DESIGN
REVIEW

INITIAL RECOMMENDATION OF THE EAST DESIGN REVIEW BOARD

Project Number: 3012300

Address: 505 11th Avenue East

The first scheme (Option 1)

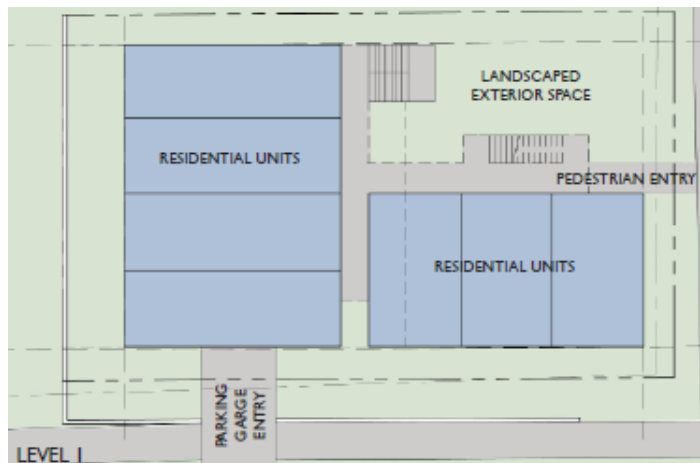
showed a zoning compliant option with 28 units in two buildings. One building was shown at the west property line and one building was shown at the south property line, with a landscaped courtyard at the northeast corner of the site. Parking access was shown near the west property line, and a pedestrian entry to the site shown at the east property line. The applicant noted that this option

requires no departures from the Land Use Code requirements, it offers space between the proposed development and the residences to the north, and it provides units facing the park for "eyes on the street" and increased safety. Cons of this option include loss of the existing 1900

structure, limited modulation facing E. Republican St, and a weaker pedestrian connection from the site to E. Republican St.

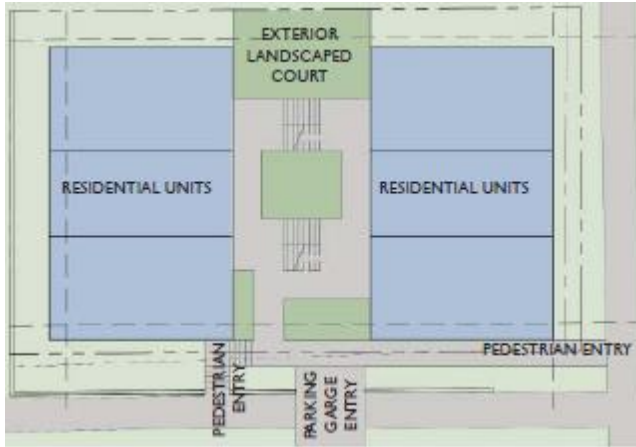
The second scheme (Option 2) showed 24 units in three buildings. One building was shown at the west property line and one building was shown at the east property line, with a landscaped courtyard at the northeast corner of the site. Parking access was shown near the middle of the south property line, and a pedestrian entry to the site shown west of the parking access. The applicant noted that this option requires two departures from the Land Use Code requirements, to reduce the required setback from the south and west property lines. Pros included a stepped south façade to respond to grade changes and give visual interest, a clear point of pedestrian entry, and units facing the park for “eyes on the street” and increased safety. Cons of this option included loss of the existing 1900 structure, limited modulation facing 11th Ave E, and a weaker pedestrian connection from the site to 11th Ave E.

interest, a clear point of pedestrian entry, and units facing the park for “eyes on the street” and increased safety. Cons of this option included loss of the existing 1900 structure, limited modulation facing 11th Ave E, and a weaker pedestrian connection from the site to 11th Ave E.

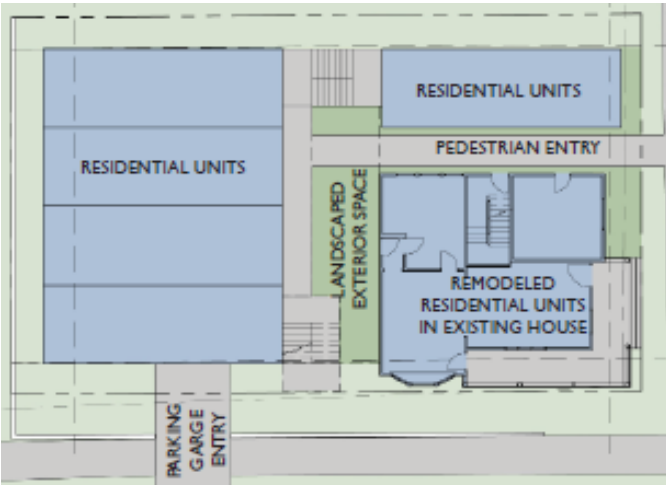
The third scheme (Option 3) showed 20 units in two buildings. One of the buildings would be the existing structure, relocated to the west edge of the site and remodeled to include 4 apartments. The other building would be a new U-shaped structure, with the primary pedestrian entry facing E. Republican St. No parking was shown with this option. This option would require departures to reduce the required setback at the west, south, and east property lines. Pros included

saving the existing 1900 structure, the front porch of the structure would face the future Park to the west, visual interest facing E. Republican St, and a strong pedestrian connection along E. Republican St. Cons included a lack of internal open space between the existing and new structures, limited building modulation facing 11th Ave E, and a weaker pedestrian connection to 11th Ave E.

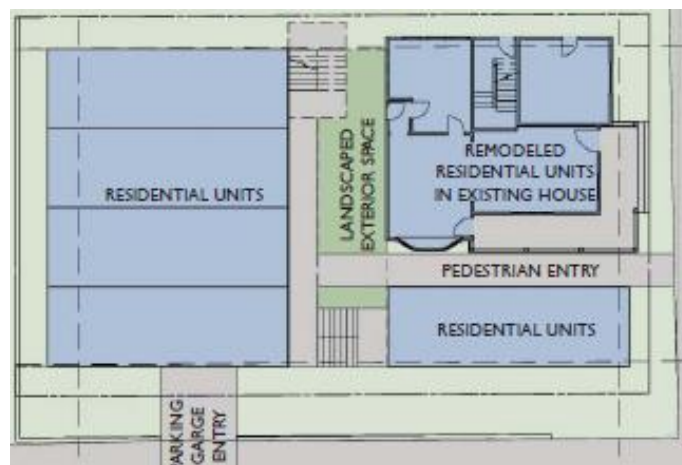
The fourth scheme (Option 4) was the preferred scheme and showed 24 units in three buildings.

One of the buildings would be the existing structure, relocated to the southeast corner of the site and remodeled to include 4 apartments. A second building would include stacked flats facing the Park to the west. A third building would be stacked flats at the north property line, and connected to the second building via exterior stairs and walkways. 10 below grade parking spaces were shown with access from E. Republican St. This option would require departures to reduce the required setback at the west and east property lines, and a departure to allow more structure width and façade length at the north property line. Pros included saving the existing 1900 structure, the front porch of the structure would face the street corner, and units facing the park for “eyes on the street” and increased safety. Cons included the impacts related to placing a lot of building mass at the north property line (shadows, bulk, scale impacts to the north).

The fifth scheme (Option 5) was presented at the EDG meeting as an additional alternative

beyond what was shown in the EDG packet. This option was similar to Option 4, but with the existing structure relocated to the northeast corner and a new structure proposed at the south property line. This option would require departures to reduce the required setback at the west and east property lines, and a departure to allow more structure width and façade length at the north property line. Pros included saving the existing 1900 structure, a more gradual massing change along 11th Ave E.

from E. Republican St, and units facing the park for “eyes on the street” and increased safety. Cons included less visibility for the wraparound porch on the existing structure, and increased shadows at the interior of the site.
